**Historic Architectural Review Commission
Staff Report for Item 6**

Application Number: H2023-0017

Address: 1200 Margaret Street

Demolition of existing covered porch, shed, and outdoor shower.

Proposed structures to be demolished in red.

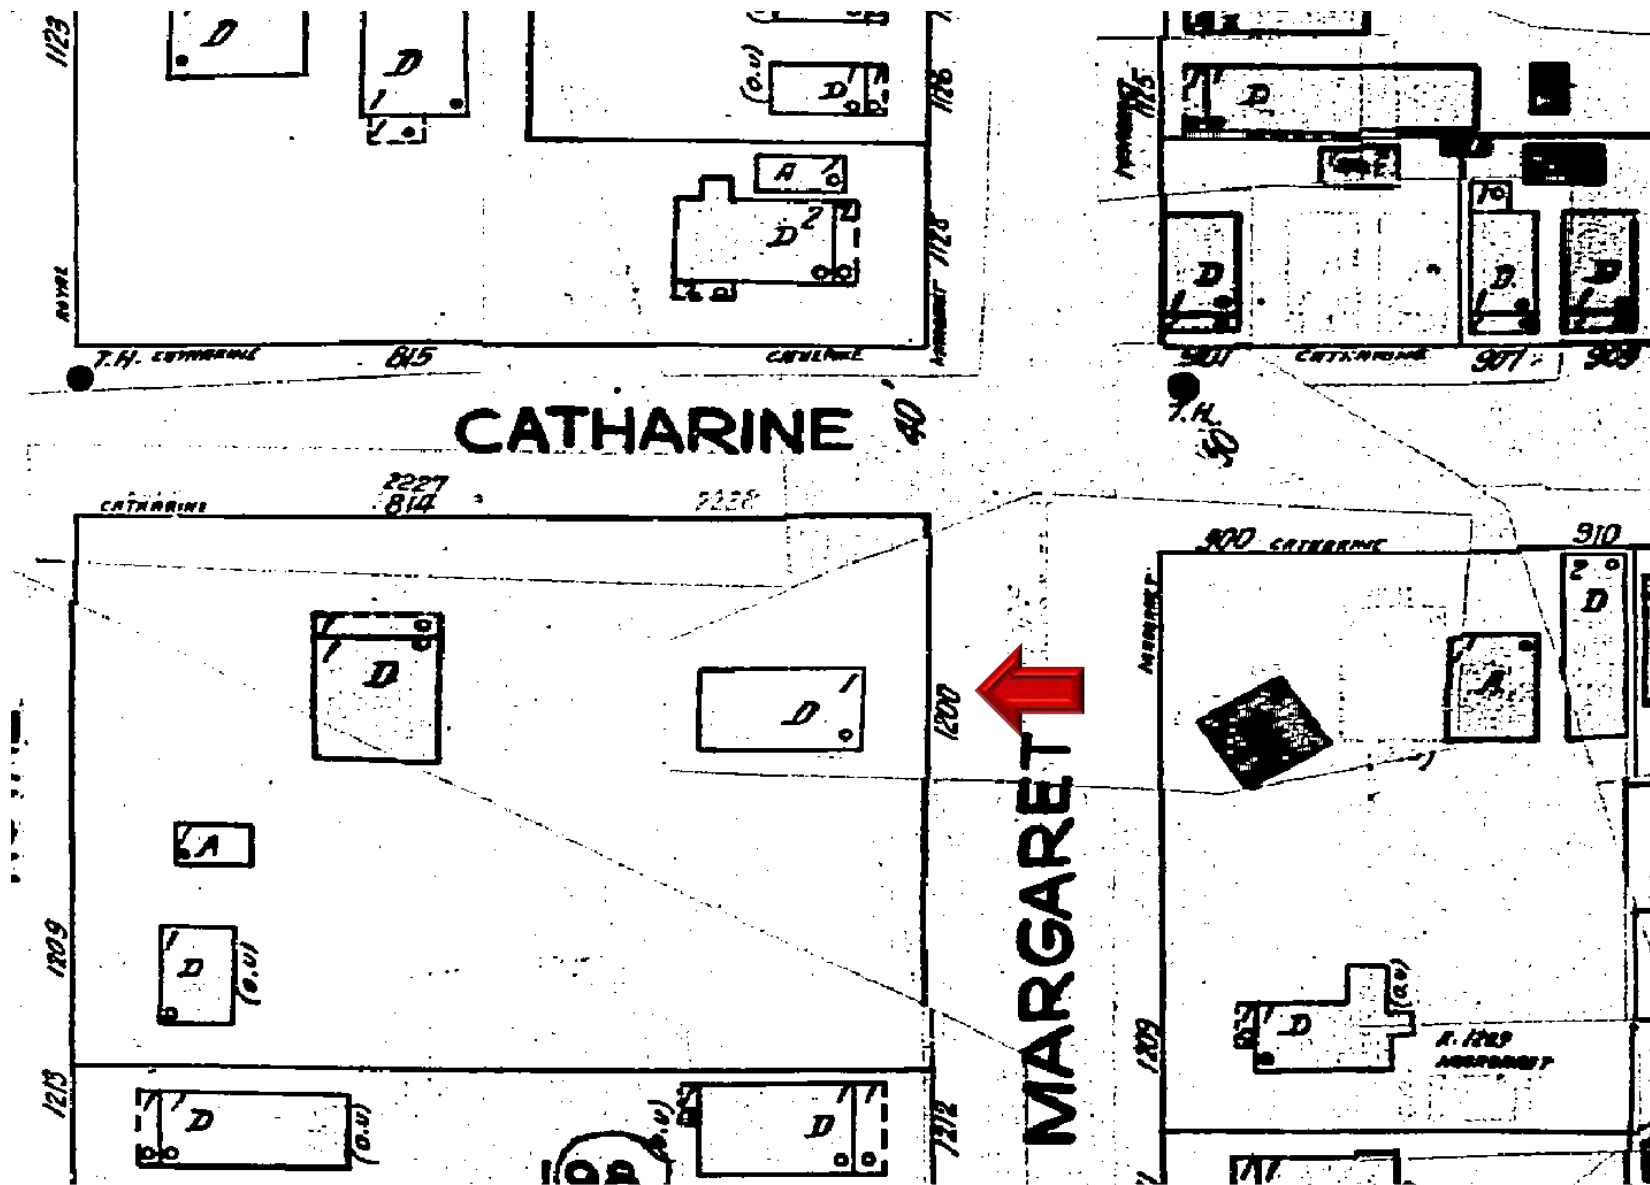
The Certificate of Appropriateness proposes the demolition of a non-historic rear addition, a shed and an outdoor shower. It is staff's opinion that the proposed demolitions will be done on non-historic and non-contributing structures and the submitted design includes replacement of the rear addition and repairs to siding, where a shed is located.

It is staff's opinion that the existing back addition and the shed attached to the north elevation diminish the historic character of the house. Their demolition and new proposed design will improve the historic fabric and the historic streetscape.

1 EXISTING SITE / DEMO PLAN
A1 SCALE: 1/4"=1'-0"

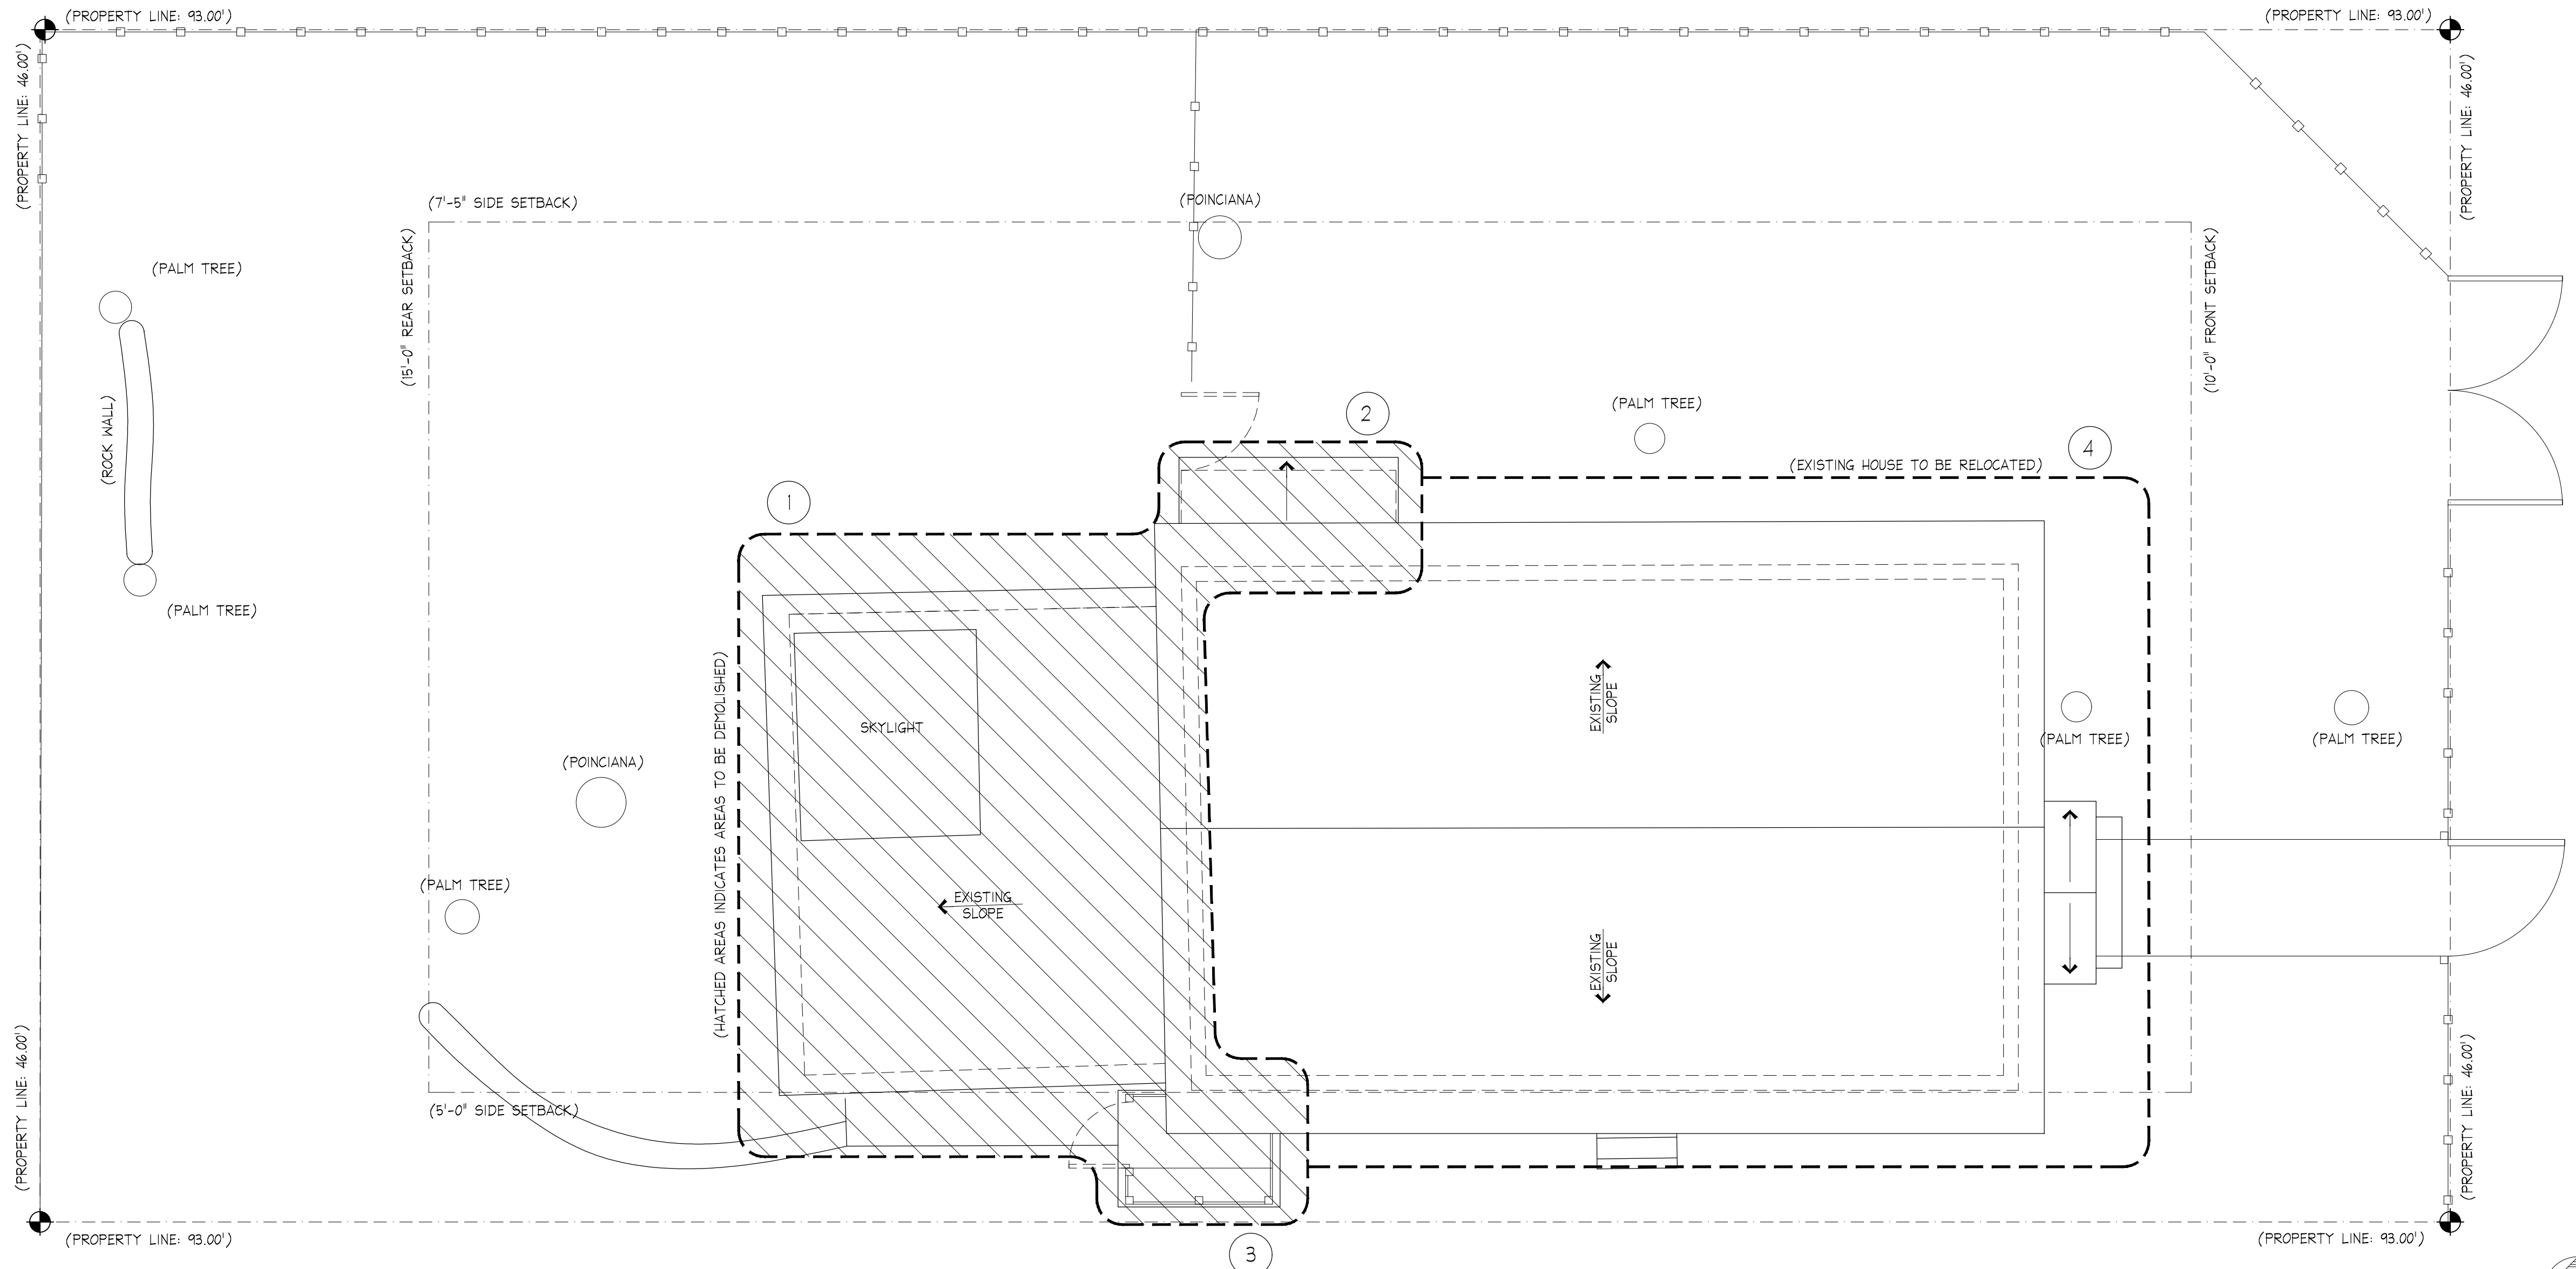
- ### CODED DEMOLITION NOTES
- 1 EXISTING COVERED SCREENED PORCH TO BE DEMOLISHED.
 - 2 EXISTING SHED TO BE DEMOLISHED.
 - 3 EXISTING OUTDOOR SHOWER TO BE DEMOLISHED.
 - 4 EXISTING HOUSE TO BE RELOCATED.
 - 5 EXISTING INTERIOR WALLS TO BE DEMOLISHED.
 - 6 KITCHEN: EXISTING APPLIANCES, FINISH FLOOR, CABINETRY, ISLAND TO BE REMOVED.
 - 7 BATHROOM: EXISTING FIXTURES, FINISH FLOOR, FINISH WALL (TILE) AND WALL TO BE REMOVED.
 - 8 INTERNAL DOOR TO BE REMOVED.
 - 9 FINISH FLOOR TO BE REMOVED.
 - 10 EXISTING WINDOWS AND DOOR TO BE REMOVED AND REPLACE. SEE PROPOSED PLANS AND ELEVATIONS.
